**FINAL DRAINAGE REPORT  
FOR  
LAZY Y AND ROCKING J SUBDIVISION**

**Project No. 25228.00**

**PCD Filing No: PPR-** 2435

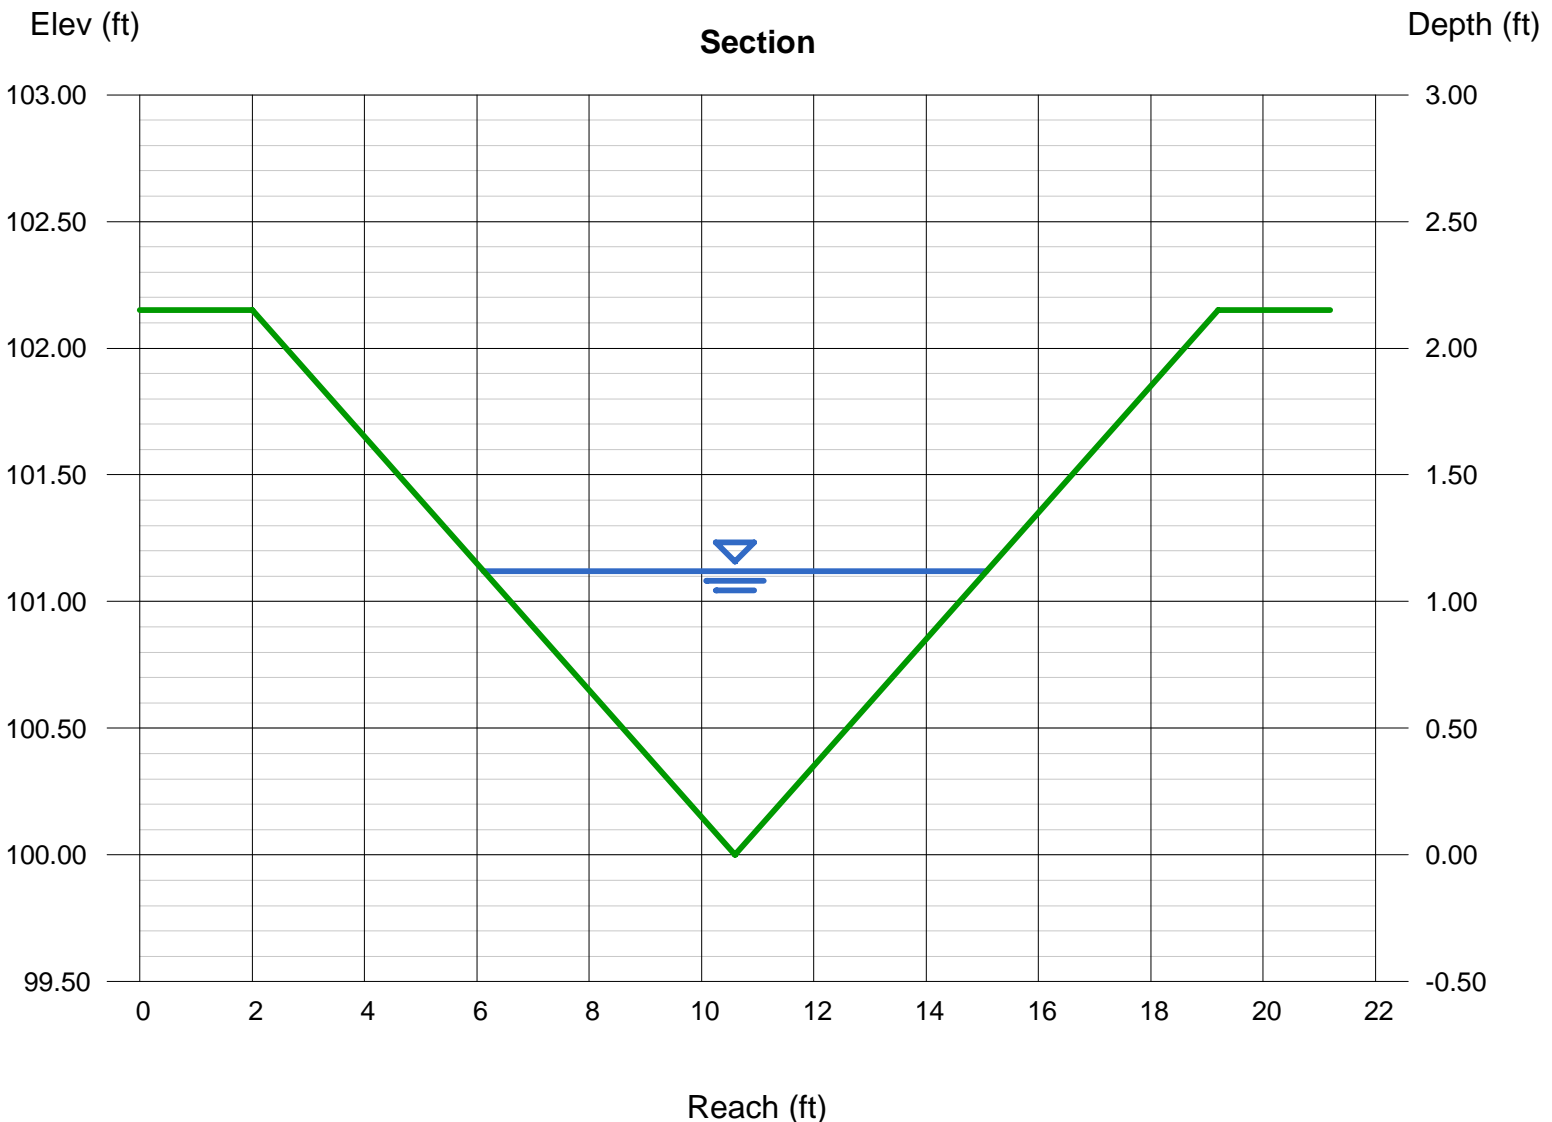
For slopes greater than 3.1% the velocities exceed 5 ft/s and erosion protection shall be provided

PROPOSED DRAINAGE MAP  
 LAZY Y AND ROCKING J SUBDIVISION  
 JOB NO. 25228.00  
 09/12/2024  
 SHEET 1 OF 1

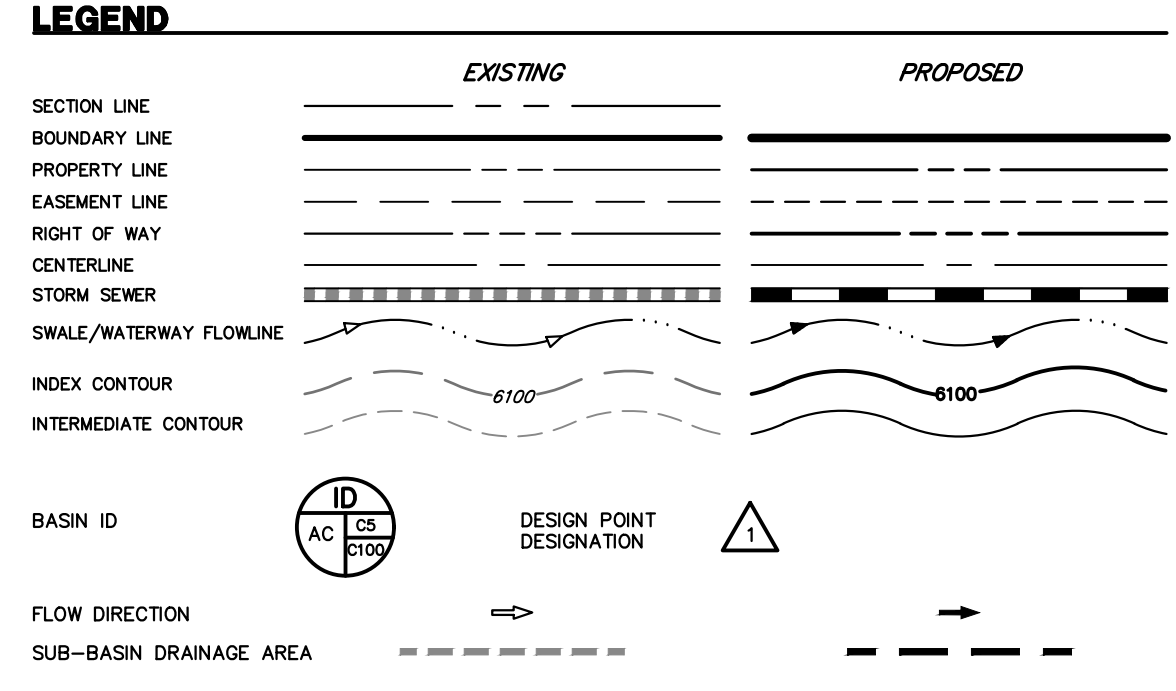
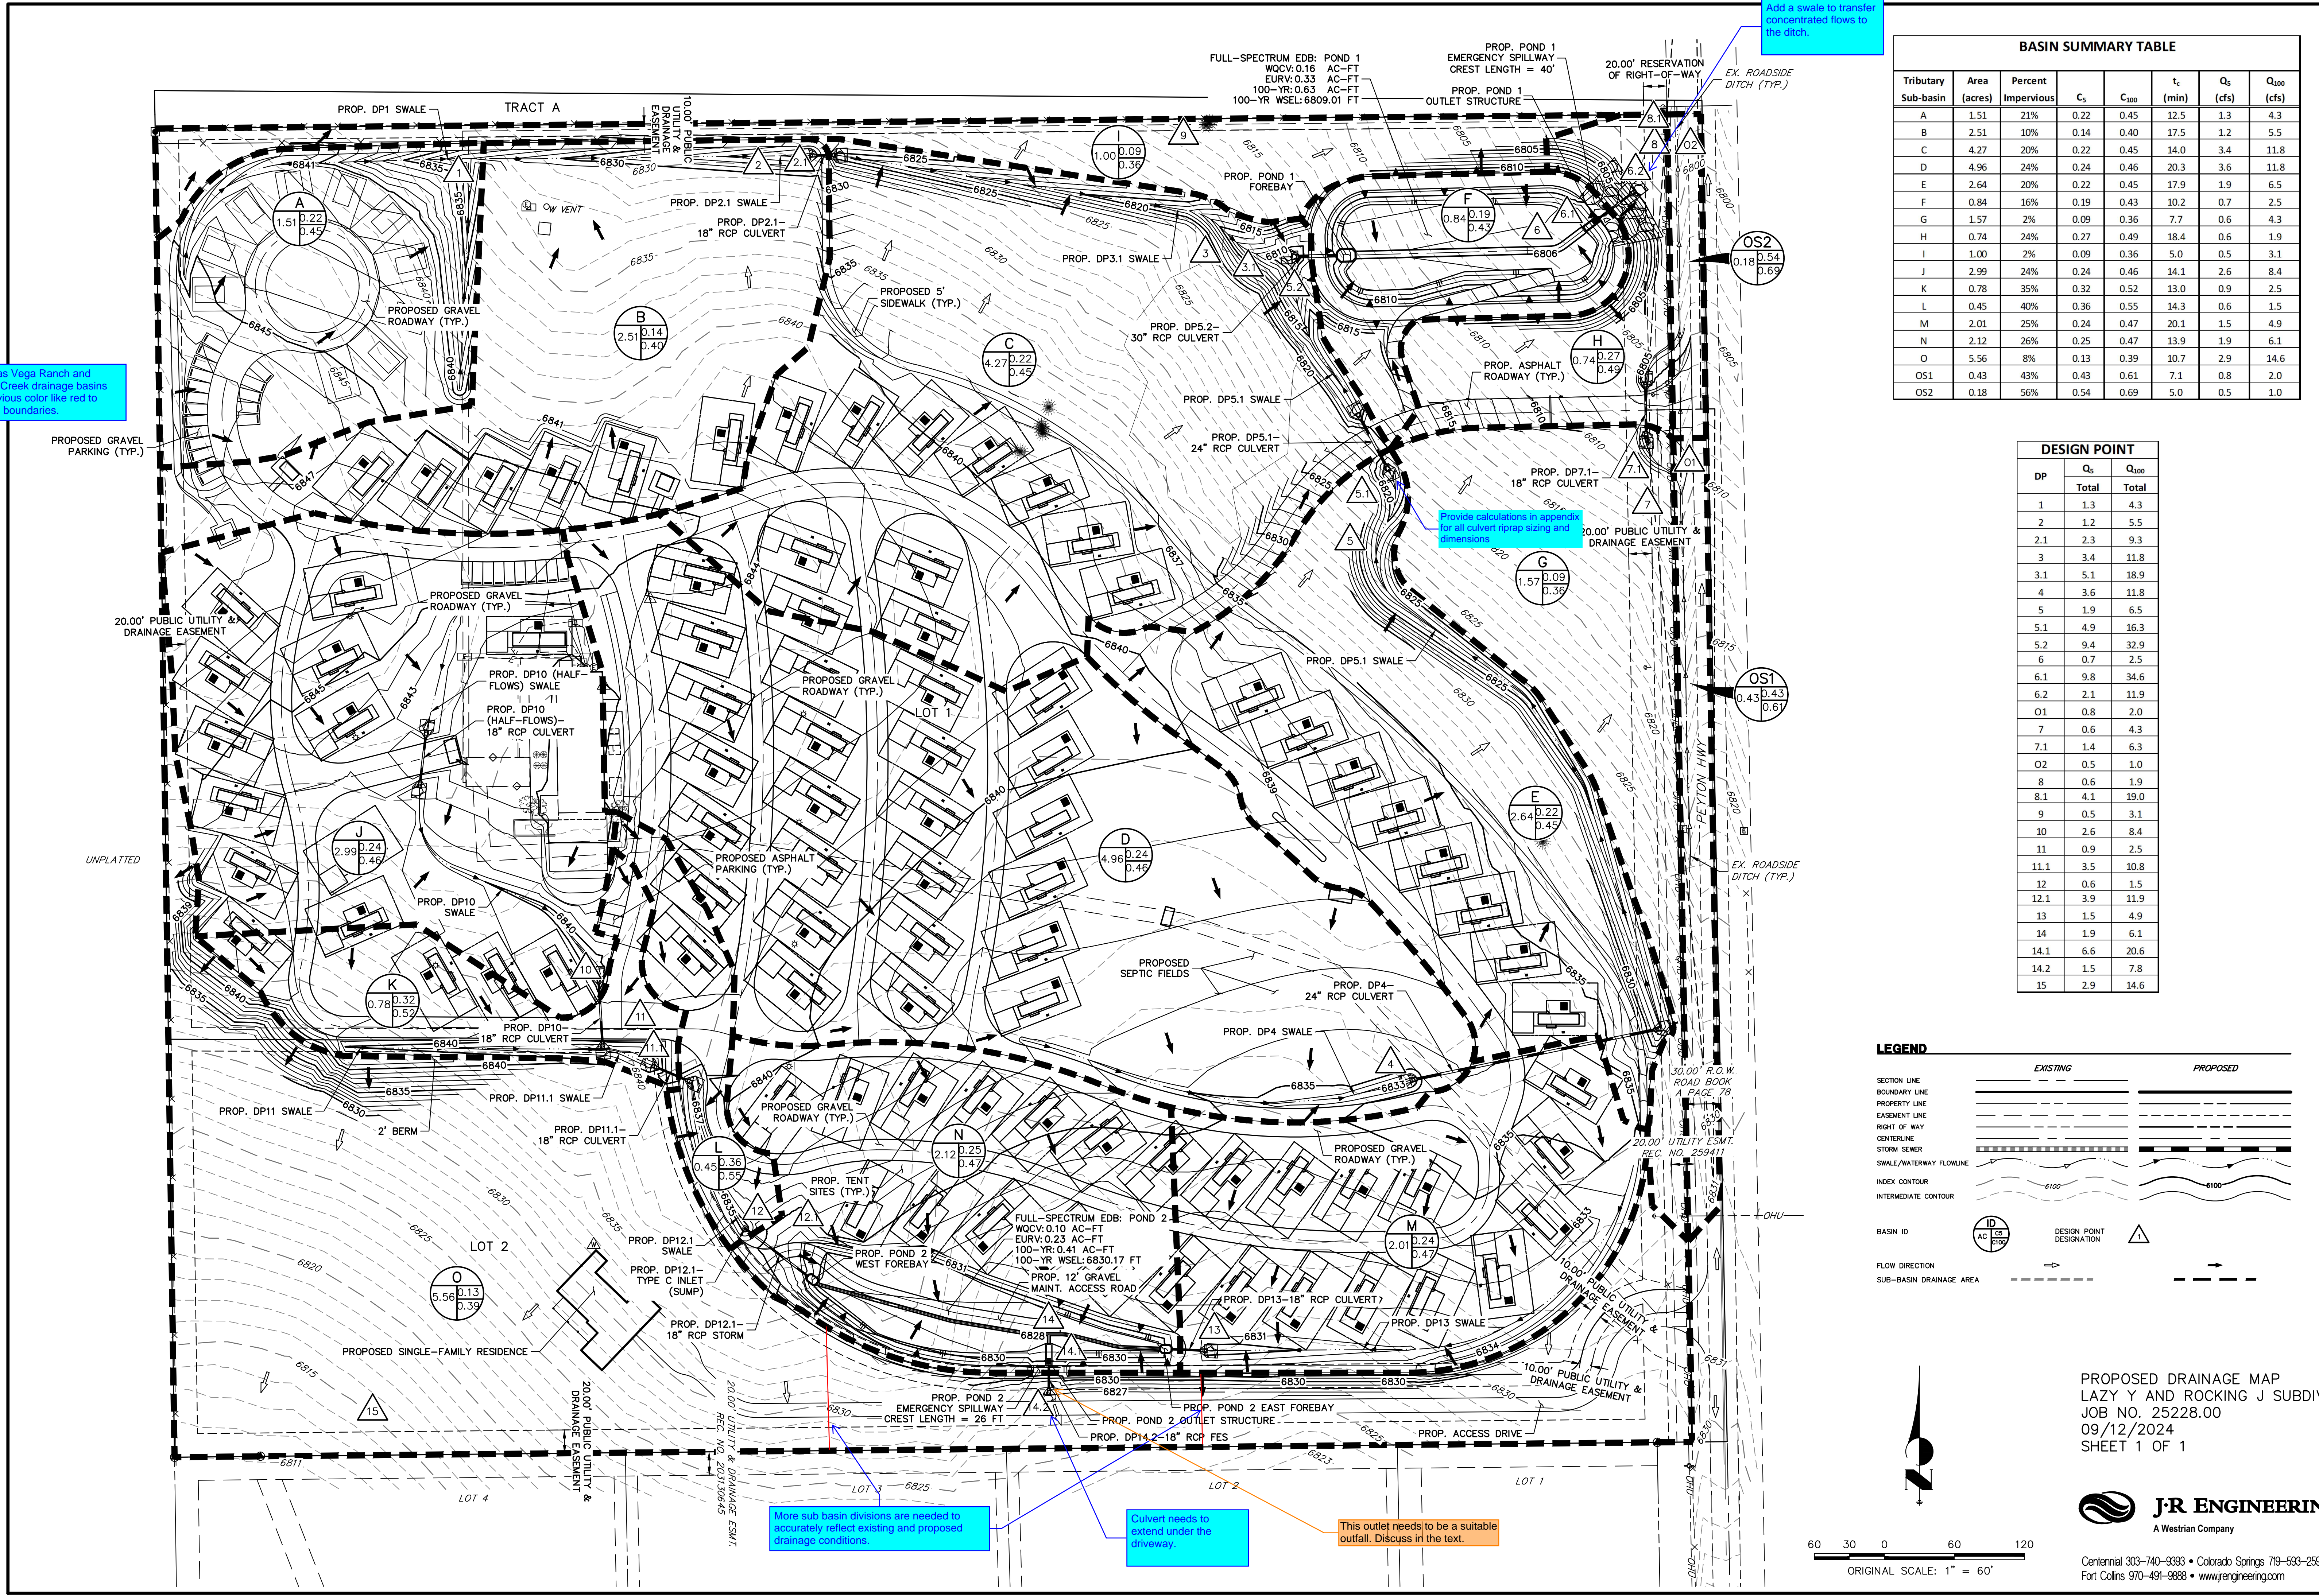
Add a swale to transfer concentrated flows to the ditch.

Clearly label Las Vega Ranch and Upper Bracket Creek drainage basins and use an obvious color like red to show the basin boundaries.

Provide calculations in appendix for all culvert riprap sizing and dimensions.

Culvert needs to extend under the driveway.

This outlet needs to be a suitable outfall. Discuss in the text.
